# SERVICE

NUMBER 164

May 16, 1958

MODEL AFFECTED: PA-24 Comanche

SKETCH "A"

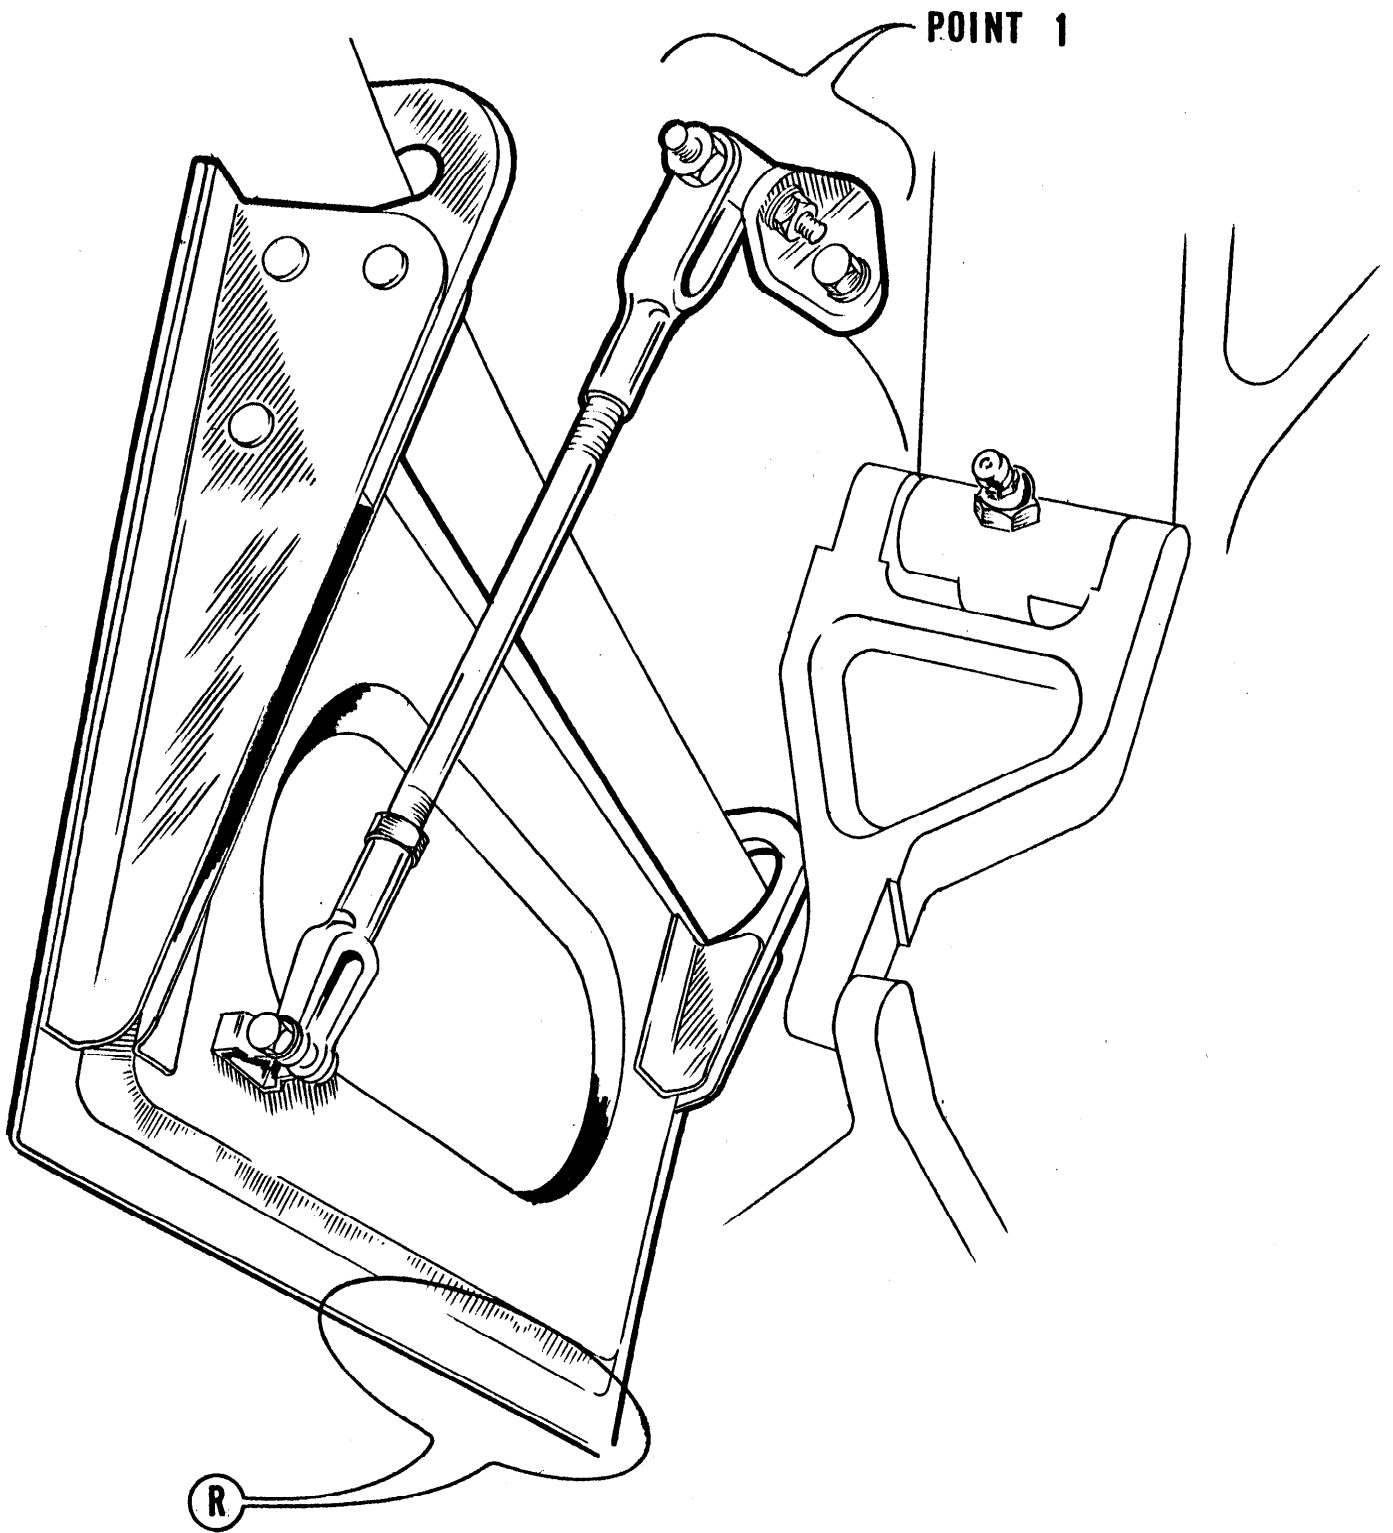
To preclude the possibility of damage to the nose gear door, it is recommended that the door retraction rod attachment on serials 24-1 to 24-76 inclusive be inspected and changed, if necessary, per Sketch "A" and instructions attached to this bulletin. The lock nut for the upper rod end fitting for the retraction rod must be removed on aircraft serials 24-1 to 24-106 inclusive.

If nose gear door rubs the gear strut when retracting gear, trim rear edge of door with tin snips in area "R".

1. Place aircraft on jacks and tail pedestal. (300 lbs. ballast on pedestal.)
2. Check eye bolt at upper end of retraction rod at point 1.
3. If eye bolt is not installed as shown, remove and reinstall per sketch.
4. Remove upper rod end fitting and lock nut.
5. Replace upper rod end fitting.
- \*6. Disconnect lower end of rod from door assembly and back off upper rod end fitting approximately two (2) turns.
- \*7. Reinstall lower end of rod to door temporarily and retract landing gear.
- \*8. Keep adjusting the rod end fitting until the door closes flush with bottom cowl skin.
- \*9. Tighten lock nut on bottom rod end fitting and complete installation of rod end to gear door.
